PLANNING COMMITTEE REPORT

PLANNING COMMITTEE		AGENDA ITEM NO: B4
Date:	6 February 2018

Application number	P2017/3389/FUL
Application type	Full Planning Application
Ward	Bunhill
Listed building	No
Conservation area	Within 50 metres of the Hat and Feathers Conservation Area.
Development Plan Context	Core Strategy: CS7 - Key Area Bunhill & Clerkenwell Employment Priority Area (General) Central Activities Zone (CAZ)
Licensing Implications	None
Site Address	Gee Street, London EC1V
Proposal	Demolition of existing boundary walls and brick substation enclosure and erection of a seven storey building to provide 3,956 sqm (GIA) office (Use Class B1a) floorspace on part ground floor and Levels 1-6 and 94 sqm (GIA) retail floorspace on part ground floor.

Sectional Analysis – Standing Person

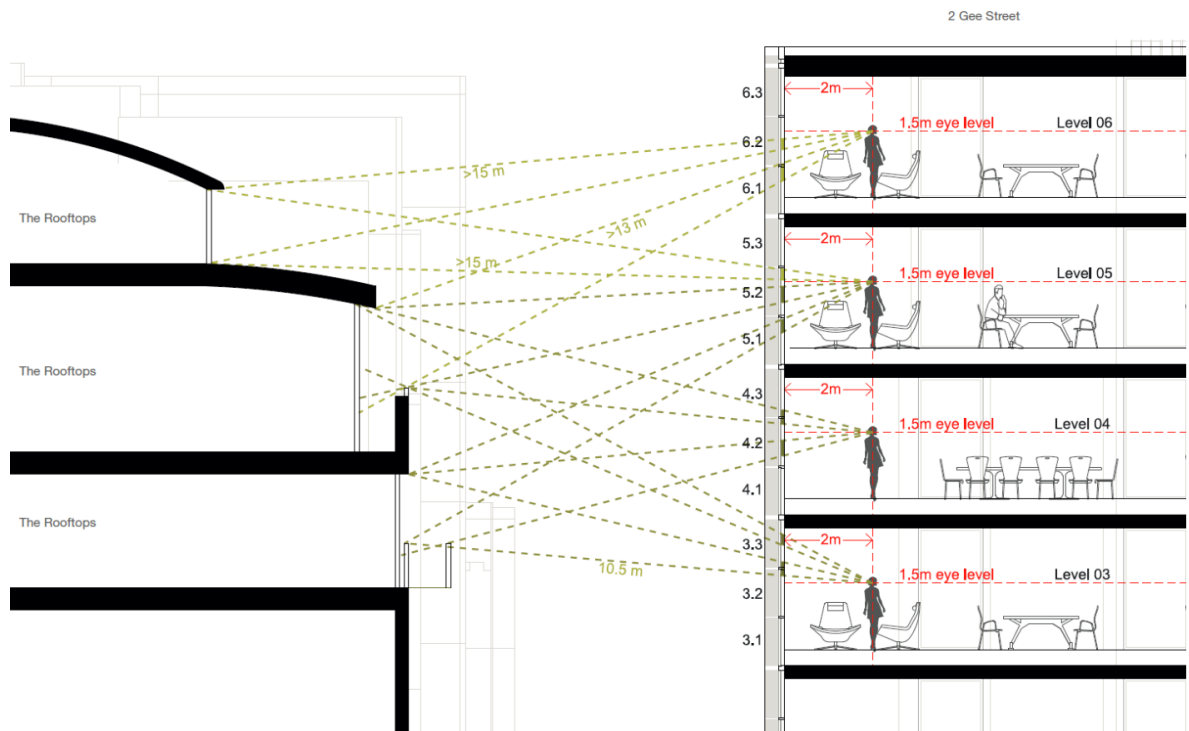
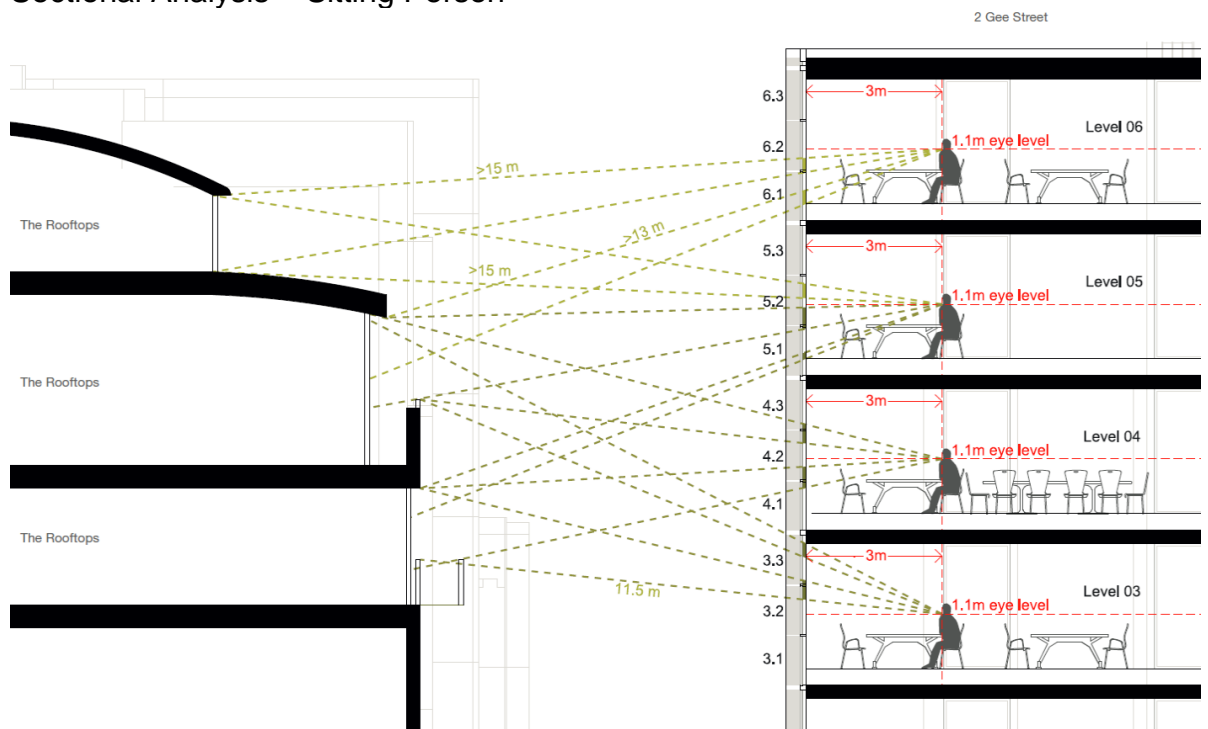
- 2.5 The applicant's submission includes a Sectional Analysis which demonstrates that occupants of the proposed development on the fifth floor may typically have opportunities to overlook dwellings over three floors at The Rooftops, whilst occupants on the third, fourth and sixth floors may typically have opportunities to overlook dwellings over two floors at The Rooftops. The assumption of a person standing 2m from the window edge within the proposed development is considered appropriate for normal office users within any future development.

The applicant proposes internal louvres to mitigate overlooking of residential units within The Rooftops. Where residential windows are directly opposite the office floorplate the louvres are rotated to block out the view, whilst where views are more oblique the louvres are orientated to allow straight views out whilst screening angled ones. The applicant has demonstrated this arrangement on the fifth floor plan below and advises that a similar exercise has been carried out for the third, fourth and sixth floors.

Location and arrangements of louvres.

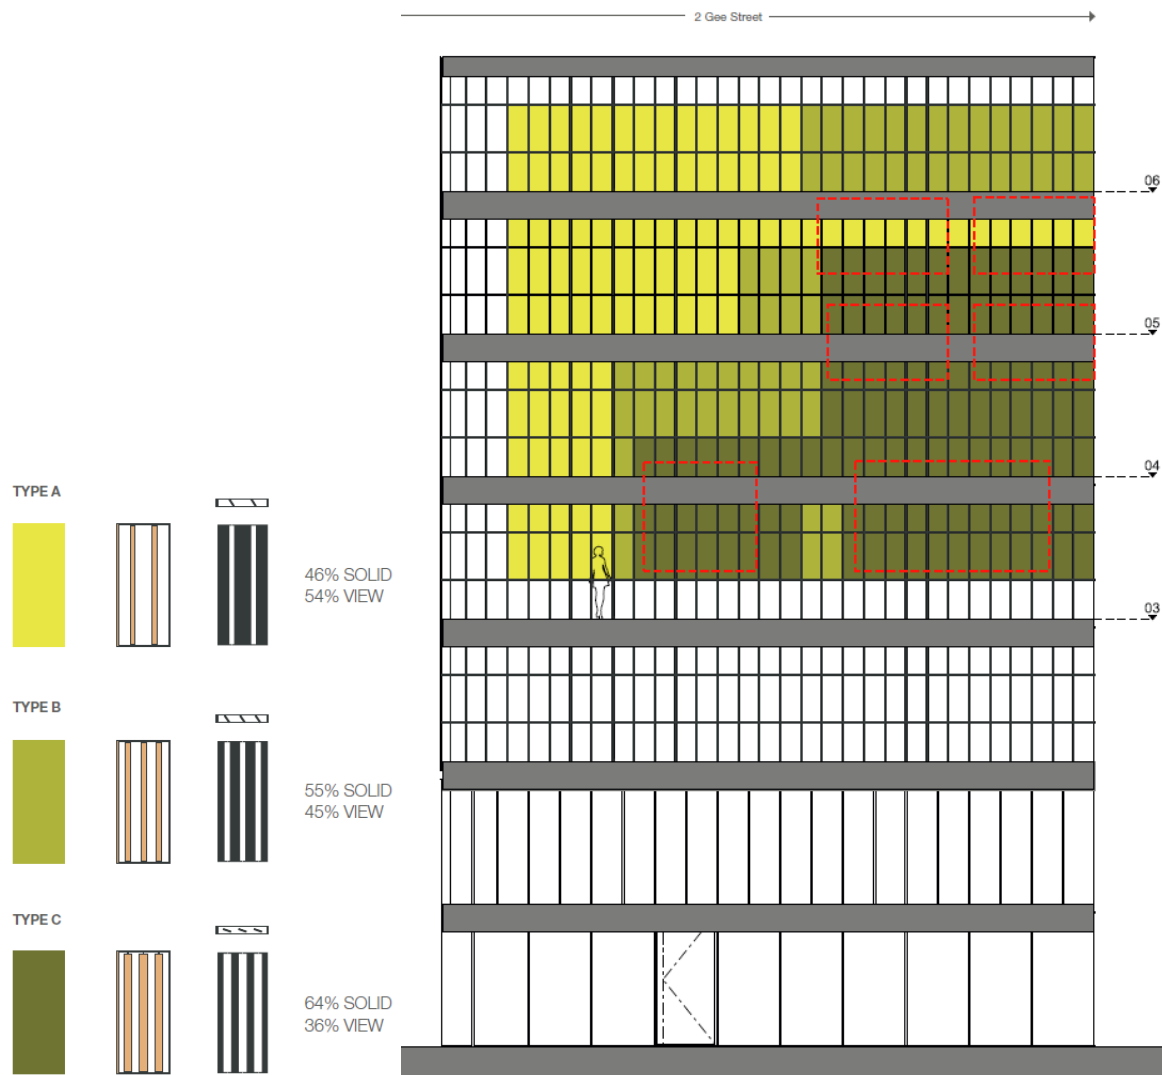
- 2.6 The applicant's submission advises that the sectional and plan analysis carried out has informed the arrangement of louvres indicated on the following diagram. The red dashed lines indicates the positioning of the residential windows at The Rooftops.

View of the Sutton Yard from dwelling within The Rooftops

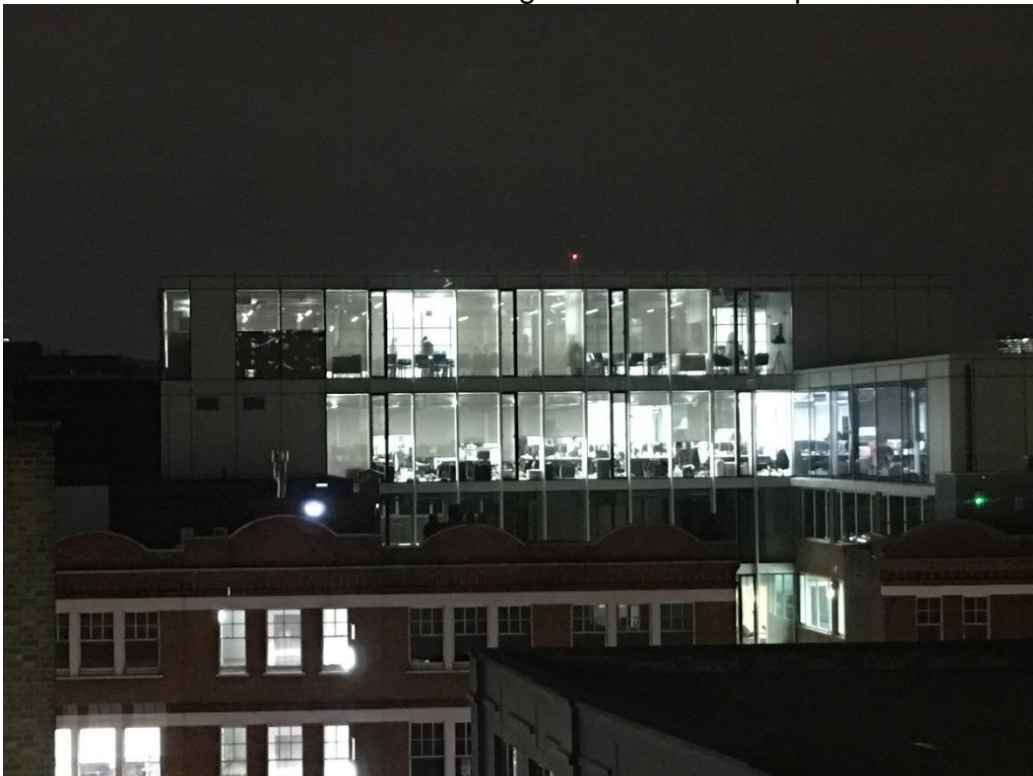
- 2.14 A photograph of the nearby Sutton Yard building has also been submitted. The accompanying representation states that this building is approximately ten times the distance from the Rooftops than the application site and results in a harmful light pollution impact.

Curtain walling bespoke cap system – Detail section

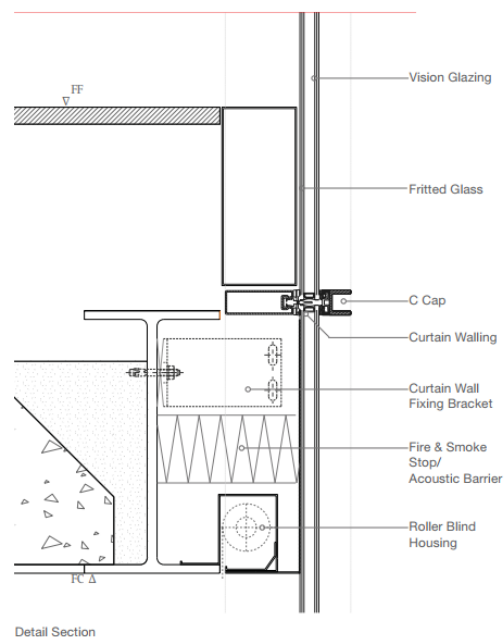
In relation to the North façade, there were some concerns raised in relation to implementation and detail and whether the design would be technically successful. The Panel felt that whilst the initial inspiration may have been a crittal façade, it appeared that due to technical constraints, a different system would be used. Panel members were also unclear about the appearance of the slabs through the curtain walling and stated that details of floor slabs and spandrels needed to be further explored/clarified.

Officer note: To provide further clarity and confidence regarding the quality of the north façade further detailed design development of the curtain walling and the bespoke caps has been carried out. The cap profiles are C and T sections and additional detail is provided within the Design and Appearance section of this report. The application submission has included eastern elevation drawings which provide clarity on the appearance of the building at ground floor level.

14.48 The application is accompanied by a detailed design for the curtain walling bespoke cap system. This responds to the comments from the DRP regarding potential technical constraints associated with the curtain walling system and its detailed appearance. The submission of this detailed design information is considered to satisfactorily address the DRP comments in this regard.

Window Map – 1-60 Parmoor Court

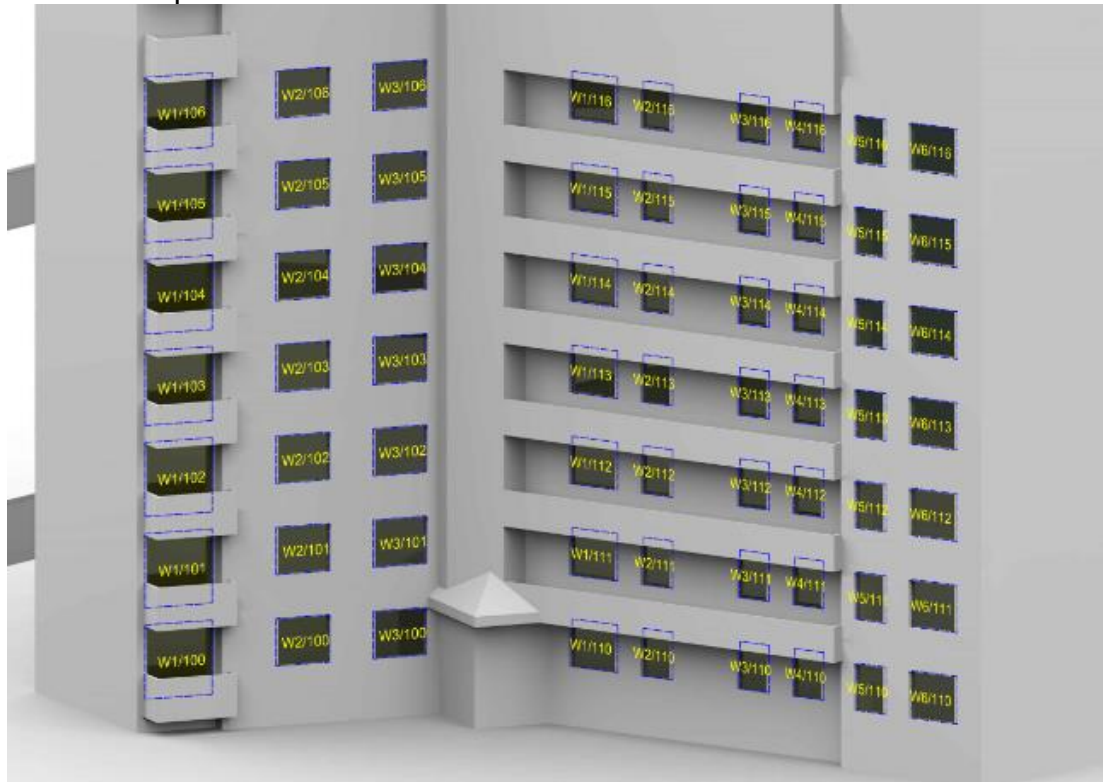
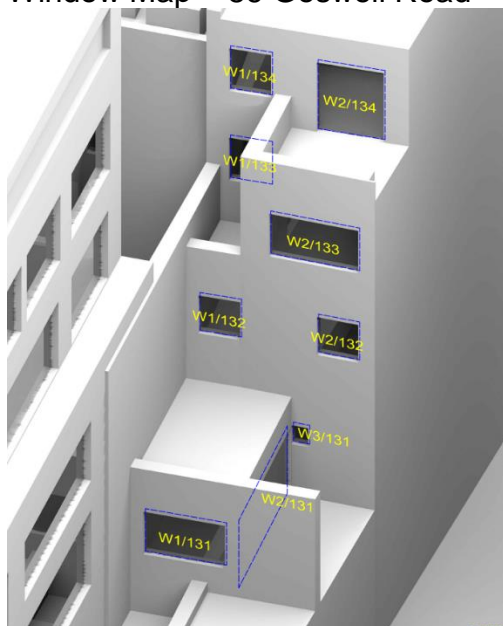
- 14.67 Two kitchens and three bedrooms at 1-60 Parmoor Court would experience a reduction in VSC and NSL in excess of the BRE recommendations. It is noted that the reduction in VSC for these units is not significantly in excess of the 20% reduction considered acceptable within the BRE Guidelines. It is also noted that the retained VSC levels are reasonable for dwellings in a built up urban context. The reductions in daylight distribution for these rooms is considered acceptable in view of the VSC results.

- 14.68 One window at 86 Goswell Road will experience a 29% reduction in VSC and a 49% reduction in daylight distribution. The report notes that this window is located directly adjacent to Moorlands and is therefore subject to a lower existing VSC level and therefore a 3.4% reduction reflects disproportionately as a percentage reduction.

Relationship of proposed building with Parmoor Court

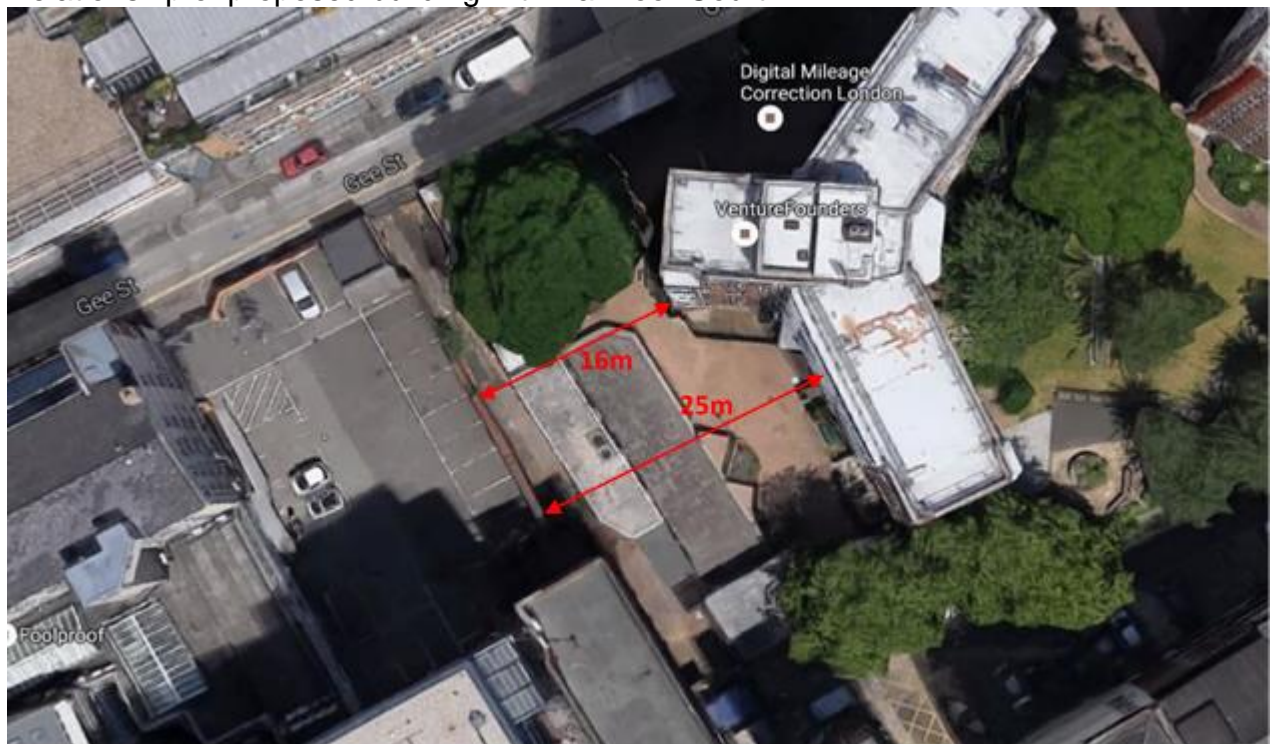
- 14.77 The proposed eastern elevation of the proposed office building would have windows facing directly towards residential units within Parmoor Court. These flats are approximately 25m from the proposed building, which is considered a sufficient distance to ensure that no unduly harmful overlooking would occur. The north-western arm of Parmoor Court includes flats which have a south-westerly outlook towards the proposed building, albeit at an oblique angle. There are two windows and a balcony served by doors on each floor. The windows are located more than 18m from the site whilst the balconies are approximately 16m from the site. In view of the distance from the proposed building and the oblique angle of the balcony doors as well as the non-residential use of the proposed development it is considered that no unduly harmful loss of privacy will occur within the accommodation served by these doors.
